Access Compliance Report Public Rights-of-Way (Pedestrian Signals)

Main Street: UNIVERSITY_DR Cross Street: IRVINE_AVE Location: S

ADA ID: SGRK211018113508 Signal Type: One Push Button-Non APS Overall Compliance: No Severity Scores: BTN 1: 35 BTN 2: N/A No BTN: N/A

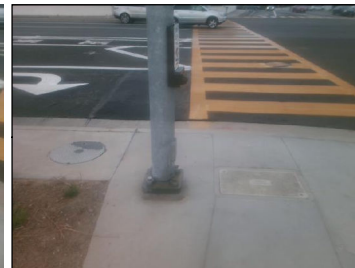
N/A B 1 FWD Approach Obstruction?	N/A	N/A	B 2 FWD Approach Obstruction?	N/A	
N/A B 1 FWD Approach Obstruction Dist (in)	N/A	N/A	B 2 FWD Approach ObstructionDist (in)	N/A	
N/A B 1 PARA Approach?	N/A	N/A	B 2 PARA Approach?	N/A	
N/A B 1 PARA Approach Constrained?	No	N/A	B 2 PARA Approach Constrained?	N/A	
Yes B 1 PARA Approach Reach (in)	0	N/A	B 2 PARA Approach Reach (in)	N/A	
N/A B 1 PARA Approach Width (in)	N/A	N/A	B 2 PARA Approach Width (in)	N/A	
N/A B 1 PARA Approach Obstruction?	No	N/A	B 2 PARA Approach Obstruction?	N/A	
N/A B 1 PARA Approach Obstruction Dist (in)	N/A	N/A	B 2 PARA Approach Obstruction Dist (in)	N/A	
No B 1 Clear Floor Space Slope (%)	3.7	N/A	B 2 Clear Floor Space Slope (%)	N/A	
Yes B 1 Clear Floor Space XSlope (%)	0.4	N/A	B 2 Clear Floor Space XSlope (%)	N/A	
N/A B 1 PAR Slope (%)	2	N/A	B 2 PAR Slope (%)	N/A	
Yes B 1 Height (in)	40	N/A	B 2 Height (in)	N/A	
Yes B 1 Pressure (#)	5	N/A	B 2 Pressure (#)	N/A

Possible Solutions: Replace Signal Push Button With APS Button. Remove and Replace Clear Space.
